# URBAN PLANNING DELEGATED COMMITTEE

#### 3.1 336 & 338 Riversdale Road and 2 Clive Road, Hawthorn East - Four storey apartment building - PP23/0472

## PLANNING ASSESSMENT

<b>Application Number</b>	PP23/0472
<b>Date Application Received</b>	27/06/2023
<b>Planning Officer</b>	Aileen Chin
<b>Applicant</b>	CDG Riversdale Hawthorn JV Pty Ltd C/- Ratio Consultants Pty Ltd
<b>Owner</b>	Cdg Riversdale Hawthorn Jv Pty Ltd
<b>Property Address</b>	336 & 338 Riversdale Road and 2 Clive Road, Hawthorn East
<b>Proposal</b>	Construction of a four-storey apartment building comprising of twenty-four (24) dwellings over basement parking in a Residential Growth Zone
<b>Ward</b>	Junction
<b>Zoning</b>	Clause 32.07 - Residential Growth Zone - Schedule 1
<b>Overlays</b>	None
<b>Neighbourhood Character Precinct</b>	49
<b>Particular Provisions</b>	Clause 52.06 (Car Parking) Clause 53.18 'Stormwater Management in Urban Development' Clause 55 (including Clause 55.07 (ResCode))
<b>Permit Triggers</b>	Clause 32.07-5 (RGZ) of the Boroondara Planning Scheme, a permit is required to construct two or more dwellings on a lot.

### **Riversdale Road**

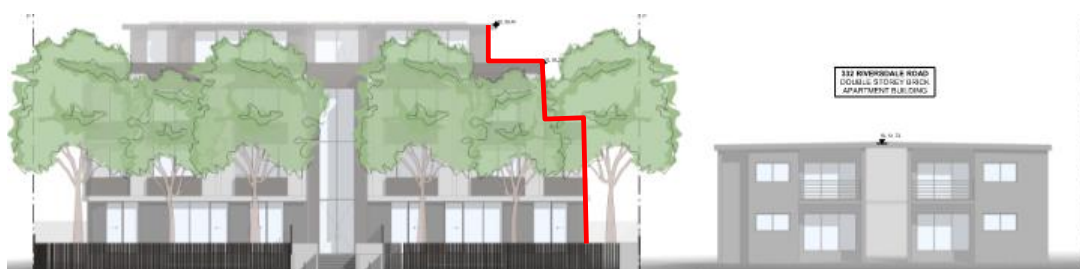
The proposed building presents as three storeys to Riversdale Road. The fourth floor is setback at all four interfaces including a minimum of 3.5m behind the Riversdale Road façade and also treated with a different material.

Council's urban designer supports the façade treatment, with the provision of a central recess effectively separating the mass into two buildings, breaking down the massing to reflect the built form grain along Riversdale Road to respond towards the preferred character outcome outlined in the NCPS. It is noteworthy that the Tribunal in its decision found that the development was satisfactory in its presentation towards the

Above: Apartment 204 balcony encroachment into Standard B17 setback (clouded)

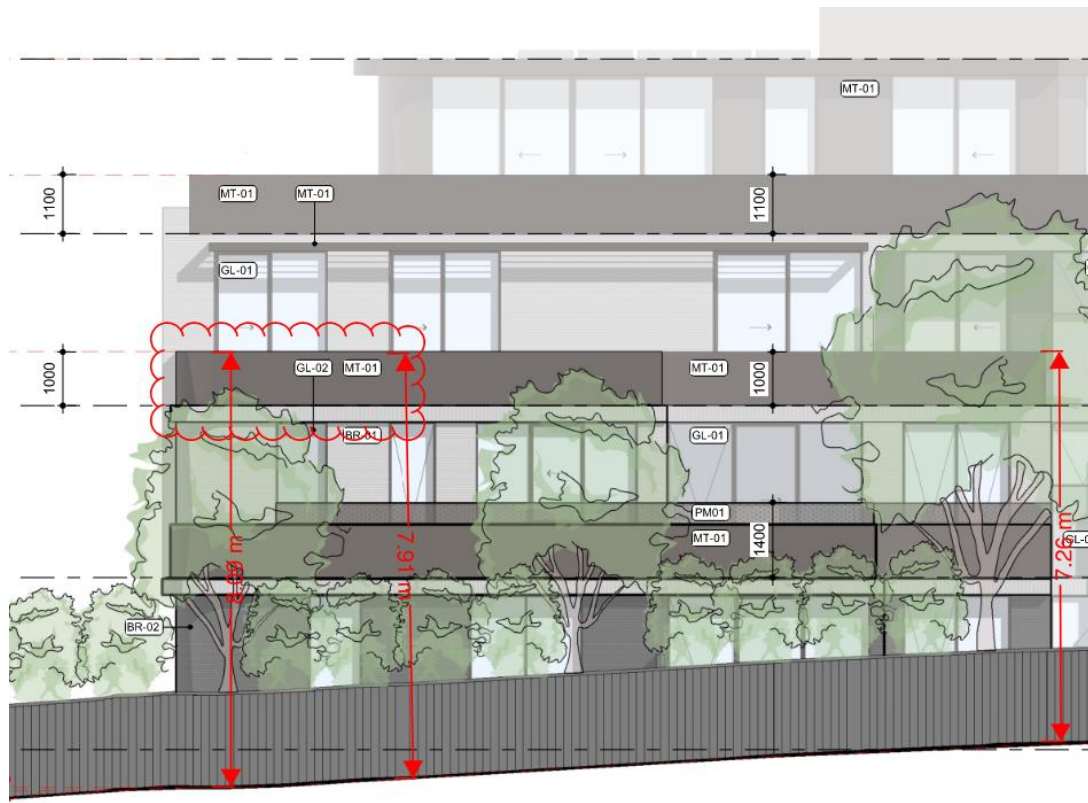
The balcony associated with Apartment 204 encroaches into the Standard by up to 180mm adjacent to Bedrooms 2 and 3. In this location, the balcony has a height ranging from 7.9m to 8.09m from Natural Ground Level which requires a setback of 3m to 3.18m respectively. A setback of 3m in this area is proposed. The area of encroachment is depicted (clouded) below.

Above: Apartment 302 & 303 balcony encroachments into Standard B17 setback (clouded)

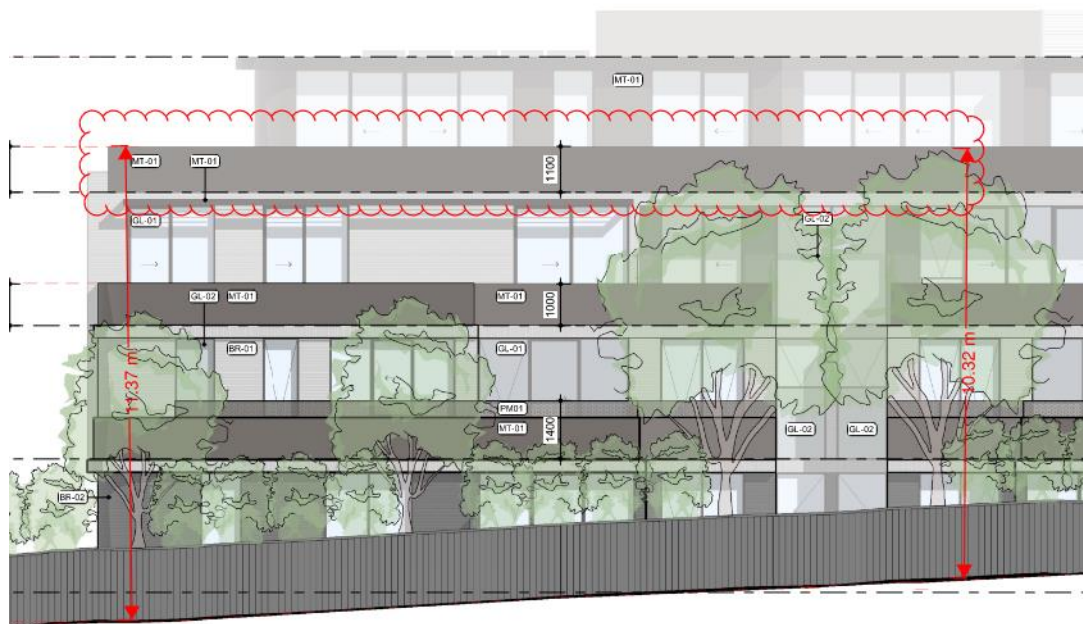
The balconies associated with Apartments 302 and 303 encroach into the Standard by up to 1.06m adjacent to Apartment 302's master bedroom and living/dining, and Apartment 303's living/dining and kitchen. In this location, the balcony has a height ranging from 10.32m to 11.37m from Natural Ground Level which requires a setback of 5.4m to 6.46m respectively. A setback of 5.4m in this area is proposed. The area of encroachment is depicted (clouded) below.

Above: Overlooking section - 4 Clive Road

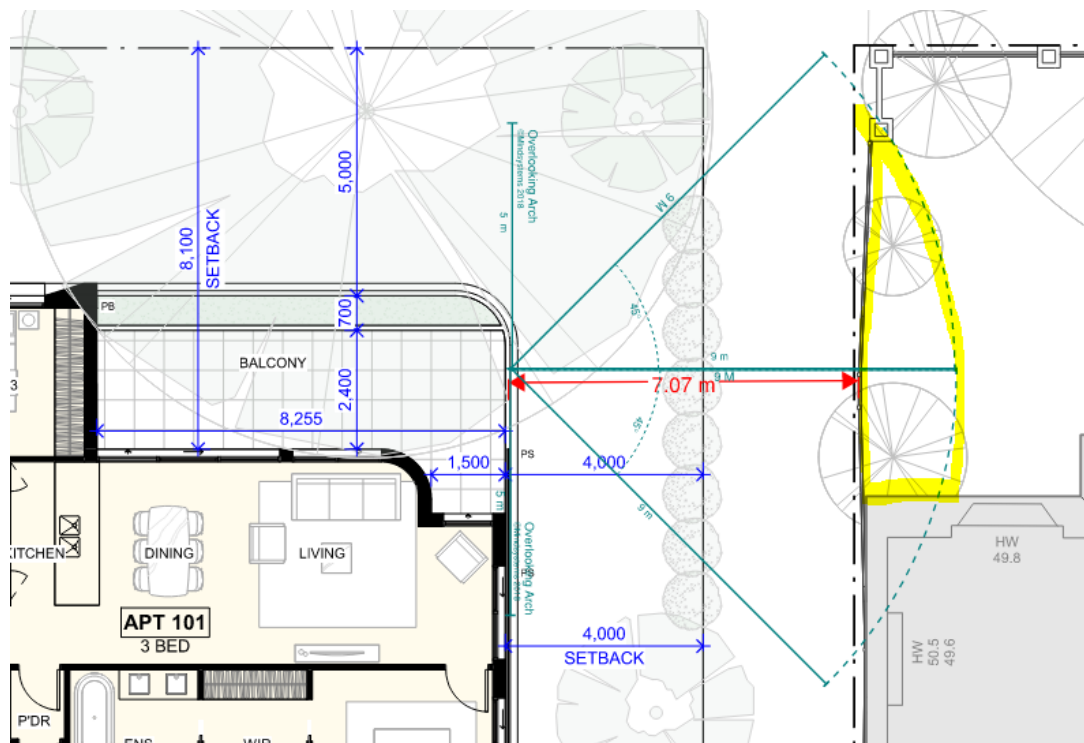
- The south-facing balcony of Apartment 202 and habitable room windows of Apartment 201 on Level 2 to be screened to comply with Standard B22 (Overlooking).
- Height of balustrade and width of planter boxes on the balcony of Apartment 301 on Level 3 dimensioned from Finished Floor Level on the South Elevation or demonstration compliance with Standard B22 (Overlooking) has been achieved.
- The south-facing balconies of Apartments 101 and 201 screened to comply with Standard B22 (Overlooking).

### 332 Riversdale Road:

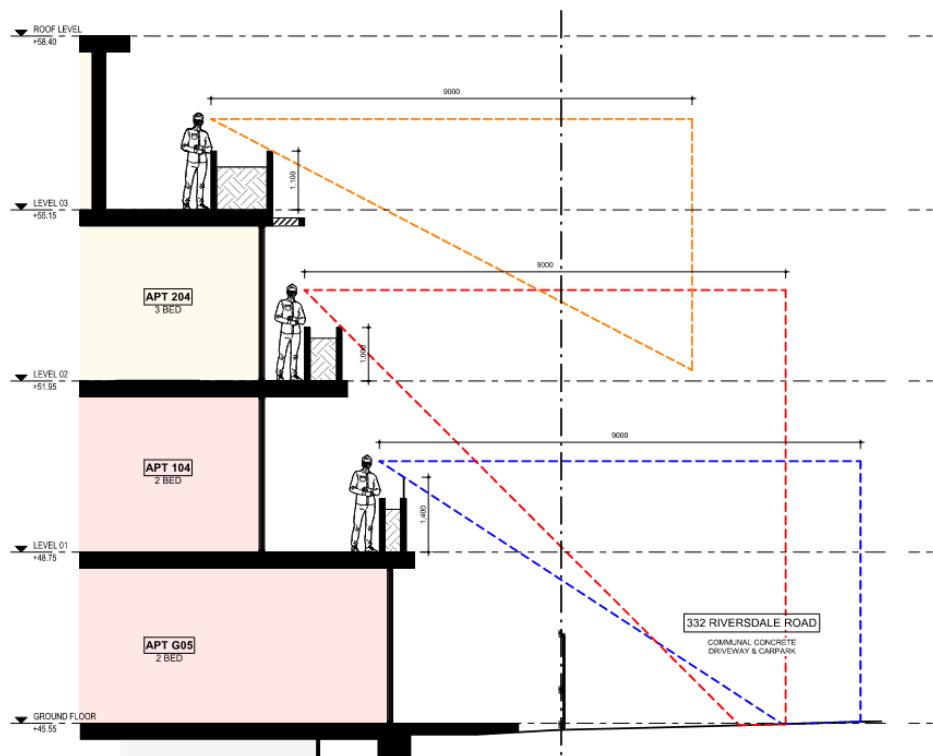
Proposed habitable room windows and upper-level balconies would not be located within 9m of any SPOS areas or habitable room windows on the adjoining property at No. 332 Riversdale Road. This is largely due to there being a driveway and large communal car park which is located between the building on the adjoining property and the shared western boundary, and the orientation of existing habitable room windows. Notwithstanding this, the first-floor west-facing habitable room windows and balconies are proposed to be screened with perforated metal screens to a height of 1.4m and planter boxes would be provided on the inside face of balconies which would provide additional separation.

It is considered the proposal would not cause unreasonable overlooking impacts to the owners/occupiers of No. 332 Riversdale Road and complies with the requirements of Standard B22.

**Tree 28** - is proposed to be retained.

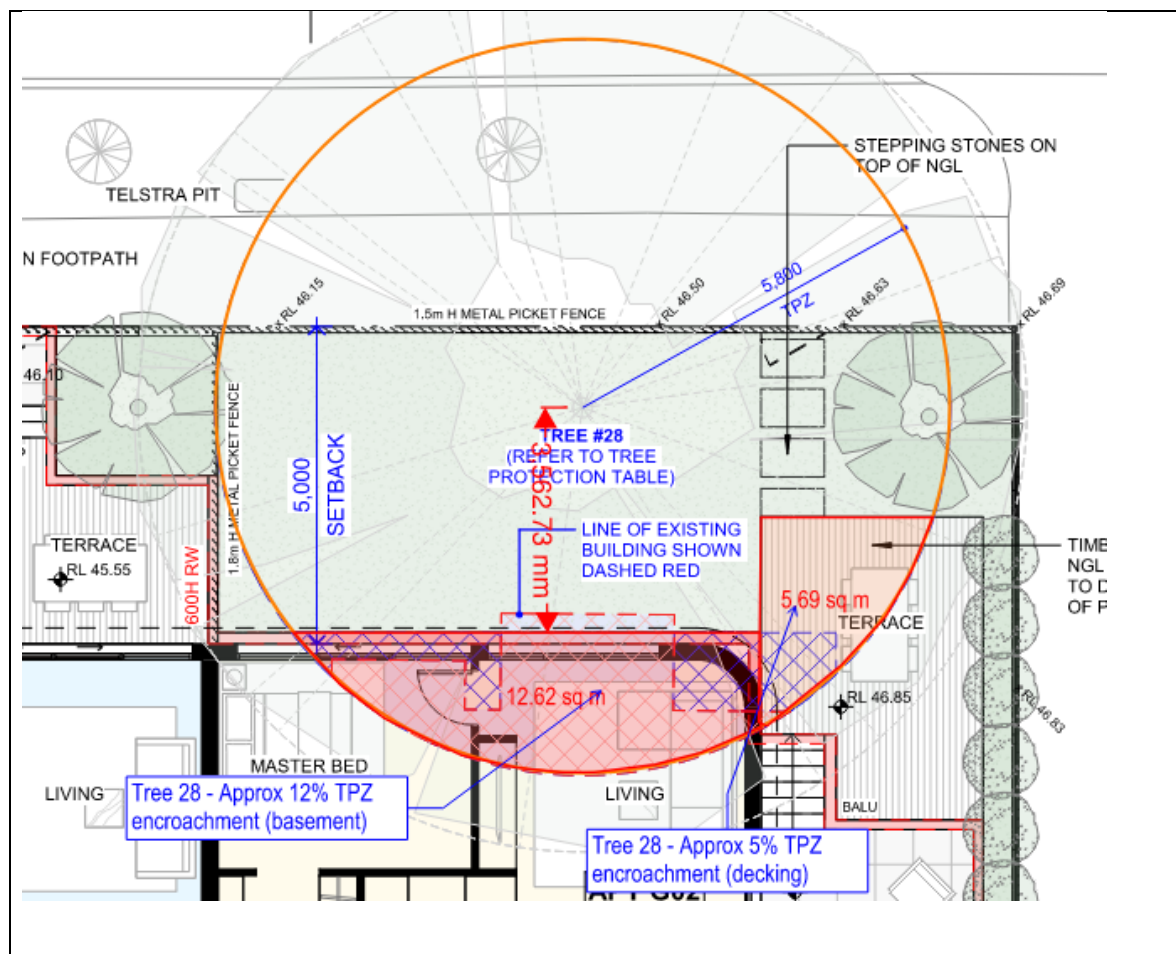
- The non-destructive root investigation identified several roots from the tree that would be impacted by the proposed development.
- John Patrick Landscape Architects have assessed that the tree will not be detrimentally impacted by the proposed works, and this conclusion was supported by council as part of PP22/0151.
- The proposed basement represents a TPZ encroachment of approx. 12%, much of which was existing within the original building footprint. The proposed decking represents a further TPZ encroachment of approx. 5%. This level of encroachment is less than that previously supported and is considered a good outcome.
- Previous advice provided as part of PP22/0151 supported construction of the basement and above floors as long as there was a minimum 3m clearance. The current proposal allows approx. 3.5m setback which would again be supported.

Above: Windows assessed to the south highlighted yellow.

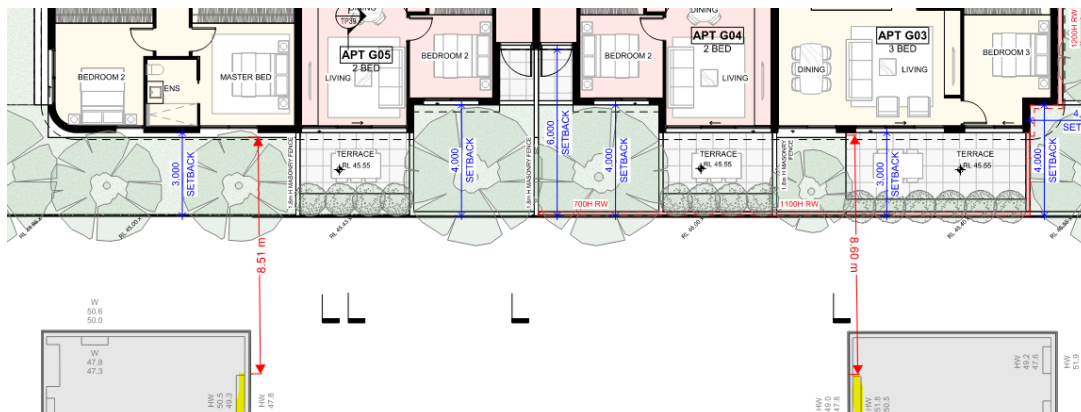
There are six north-facing habitable room windows on the adjoining property at 4 Clive Road. Five out of six of the windows are positioned on the same alignment. The windows assessed in the table above are highlighted below:

1 SOUTH ELEVATION  
SCALE: 1:100

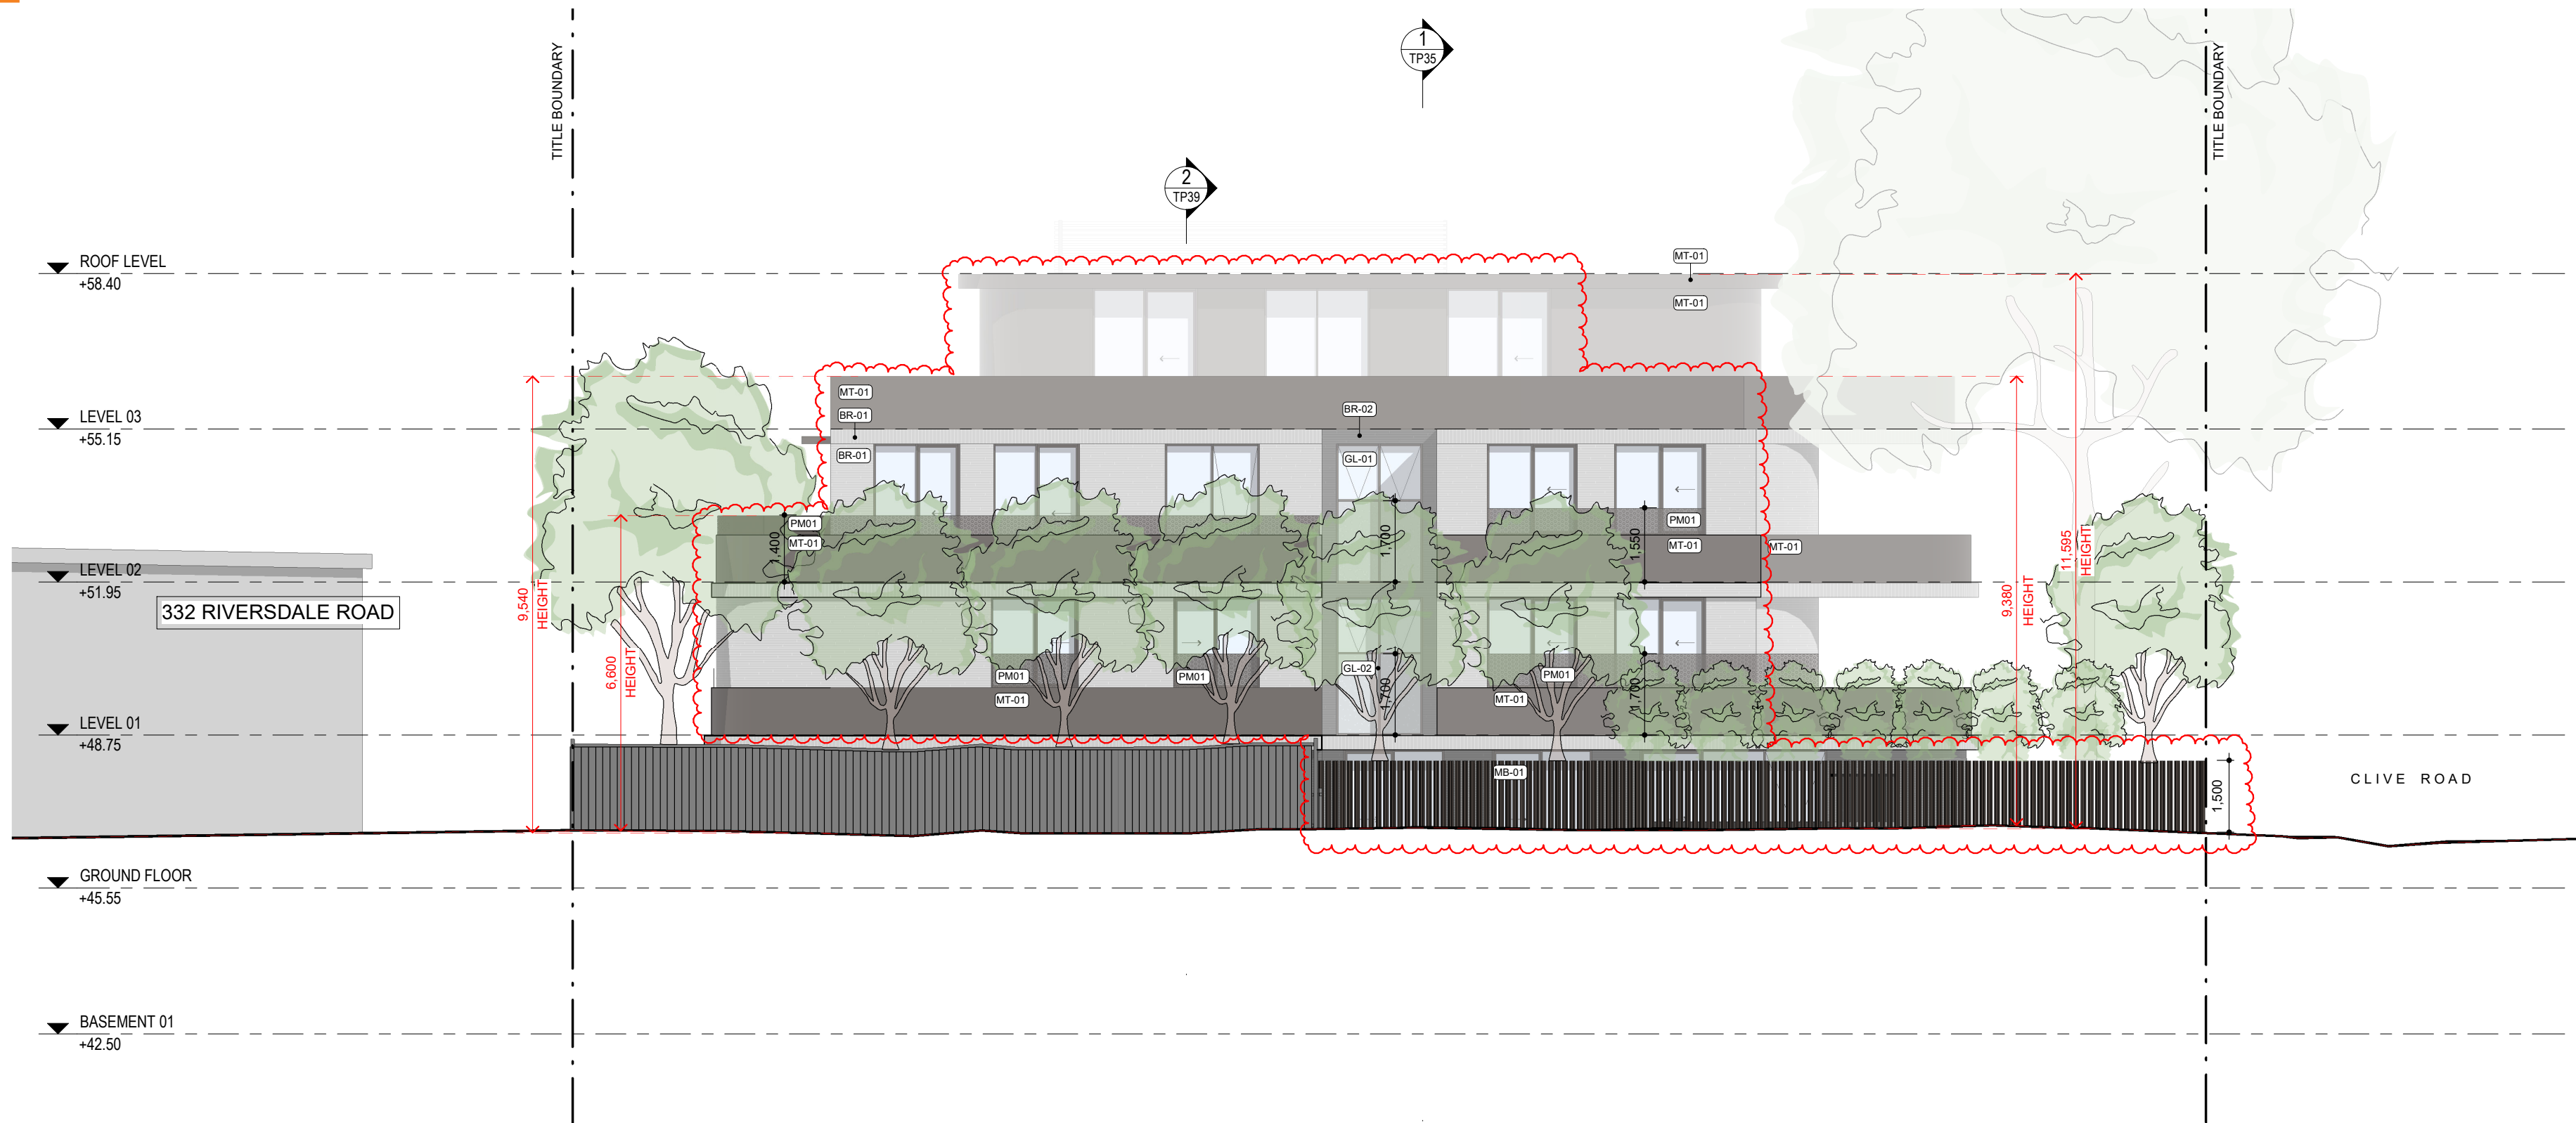
- b. Height of balustrade and width of planter boxes on the balcony of Apartment 301 on Level 3 dimensioned from Finished Floor Level on the South Elevation or demonstration that compliance with Standard B22 (Overlooking) has been achieved.
